Review of Utility Company Request for New Conduit/Pole Location

Utility Gas Electric Telephone University Ave, Between Riverside St & VFW

RE: TC Systems Inc. (AT&T)
Petition for Grant of Location – University Ave

TRENCH DETAIL

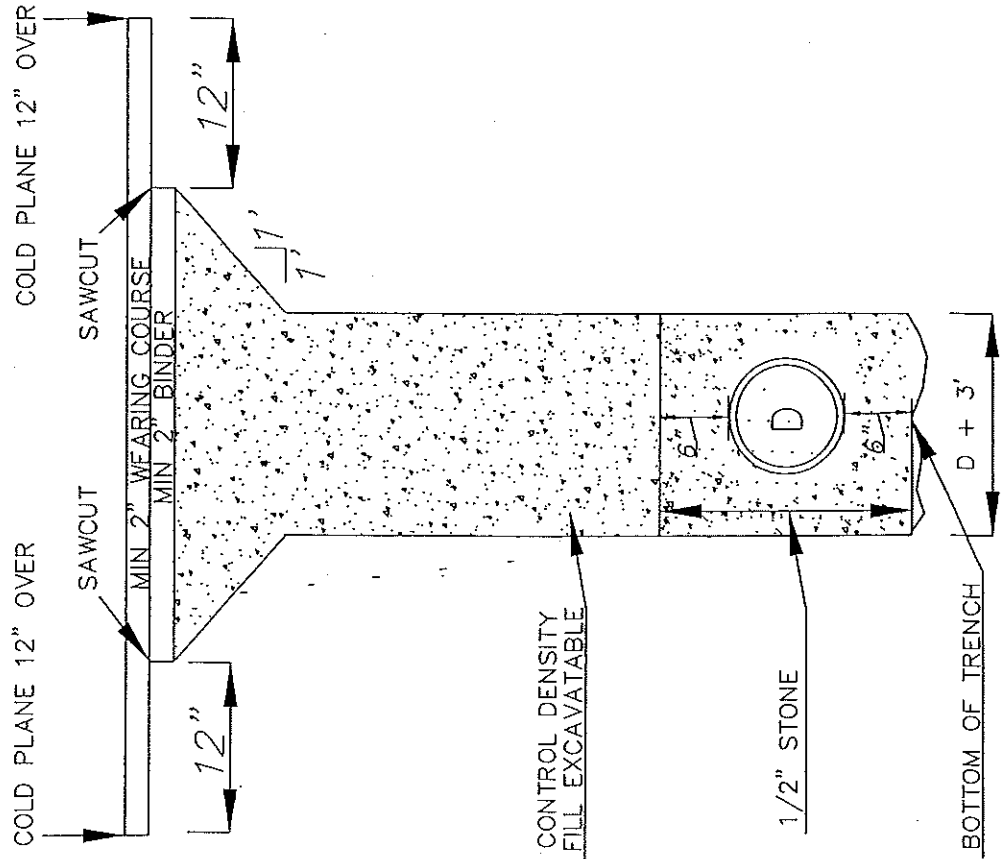
Contractor shall construct proposed trench per trench detail attached. If sawcut limit is located less than or equal to 36" from either curbline or center line of roadway, wearing surface shall extend to either curbline and/or centerline of roadway.
